STATE OF NORTH CAROLINA
DEPARTMENT OF TRANSPORTATION

NOTICE TO PROSPECTIVE BIDDERS
ADDENDUM NO.1 REVISED

CONTRACT ID: DG00459
WBS ELEMENT NO.: 17BP.7.C.5
COUNTY: GUILFORD
MILES: 0.069
ROUTE NO.: NC 62
LOCATION: PIPE #40 2053 ON NC 62 0.1 MILES SOUTH OF THE INTERSECTION
WITH SR 3121 (FERGUSON ROAD)
TYPE OF WORK: GRADING, PAVING, SHOULDER CONSTRUCTION, GUARDRAIL,
AND PIPE CULVERT

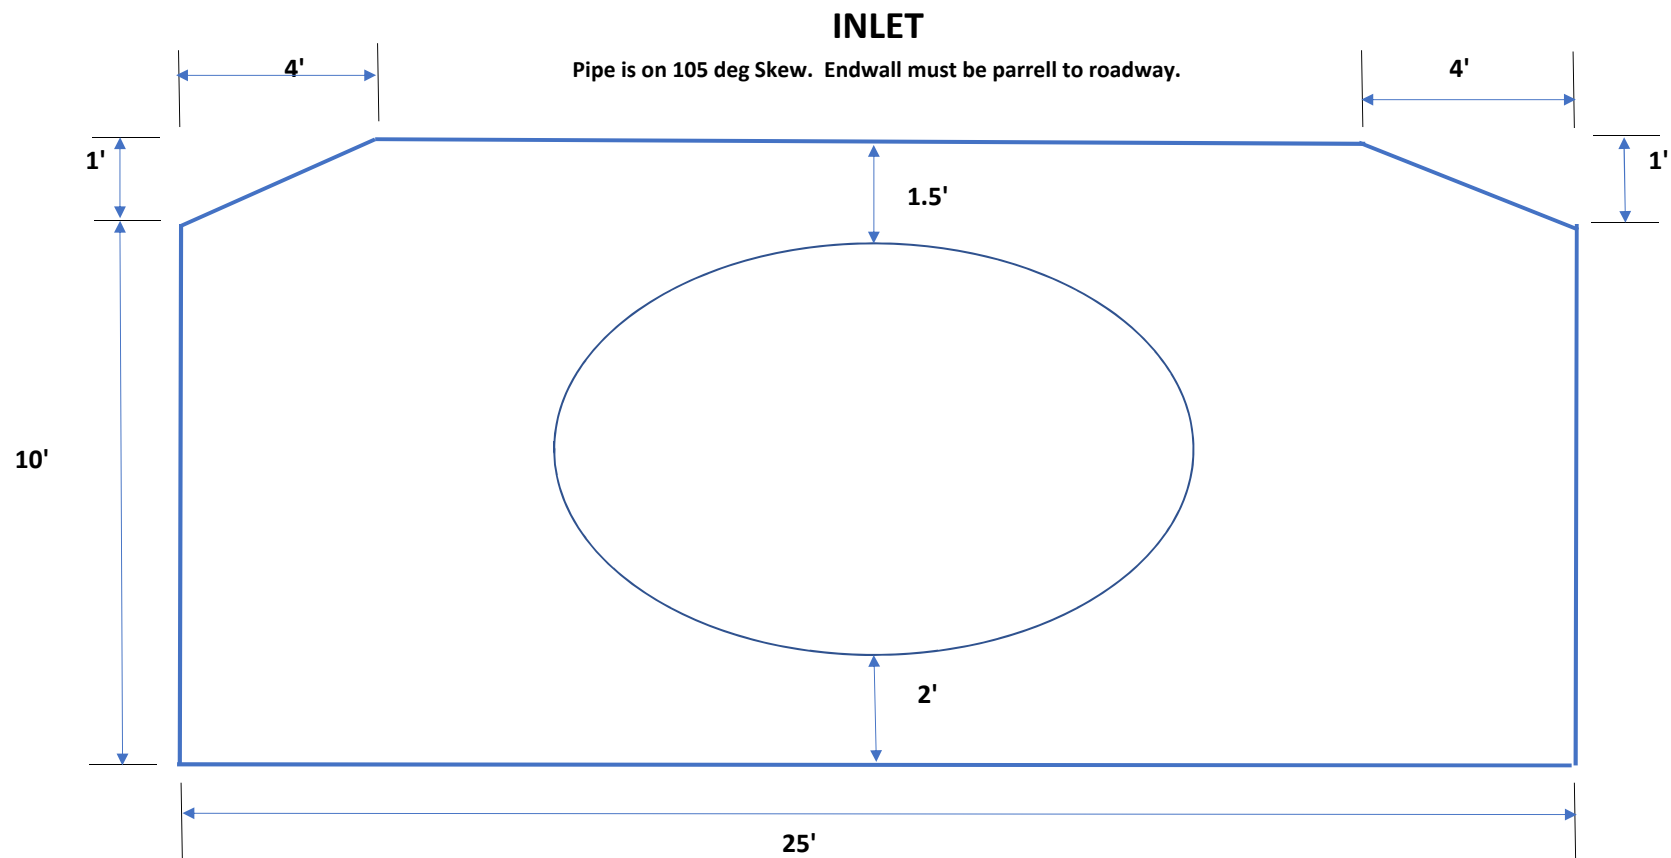
Dimensions for the headwall and endwall on this project were left off of the plans.
Required dimensions are found on the attached drawings.

OUTLET

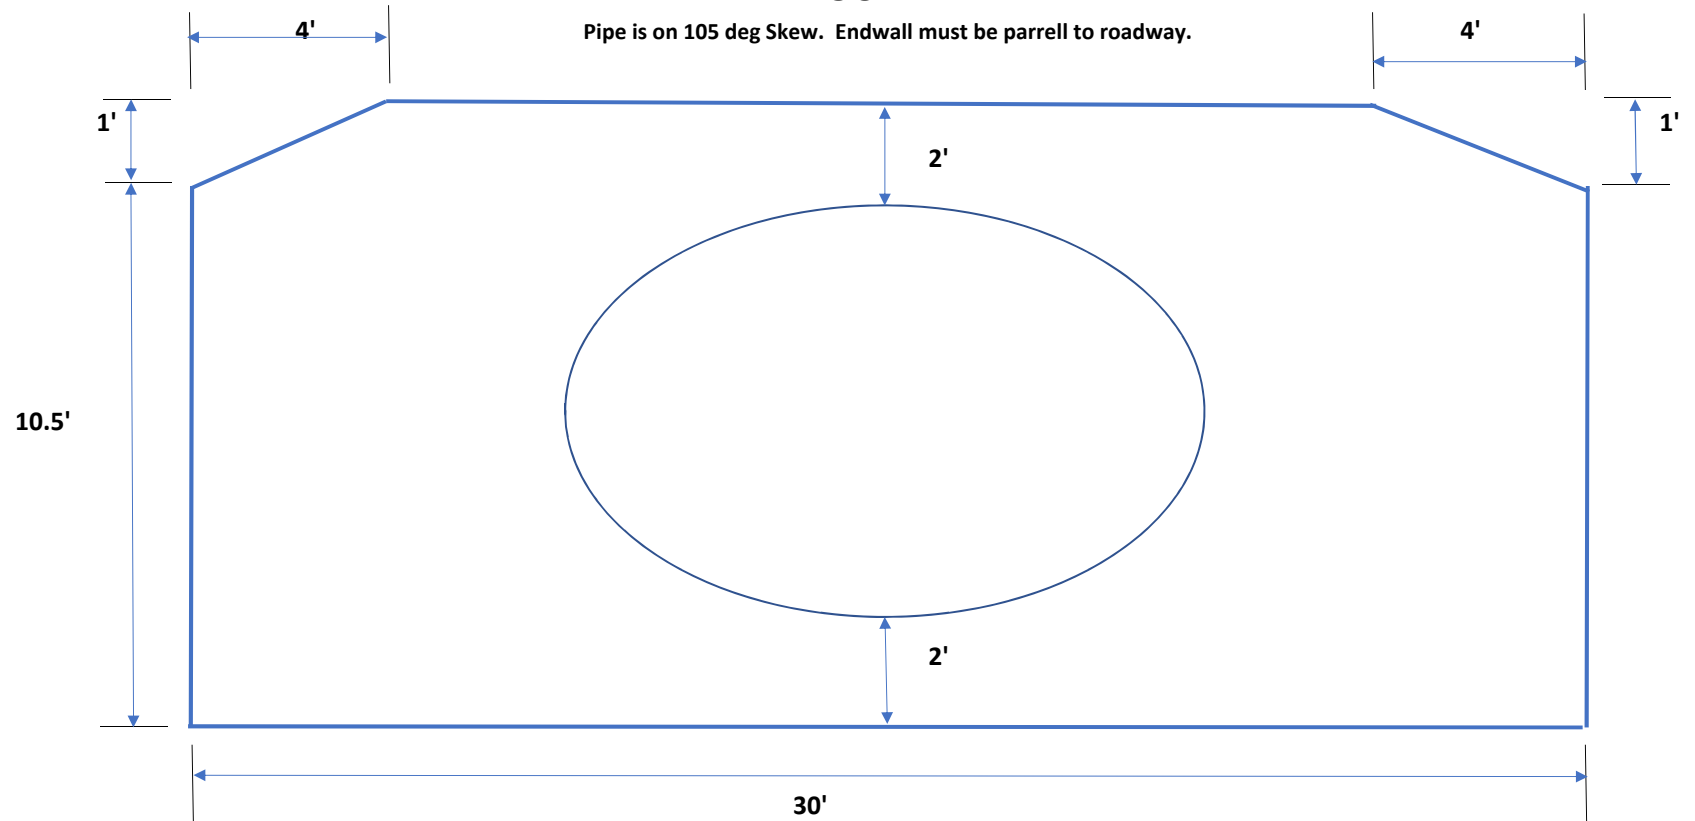
Pipe is on 105 deg Skew. Endwall must be parrell to roadway.

NOTES: Curtin Wall may be cut in field to fit conditions.
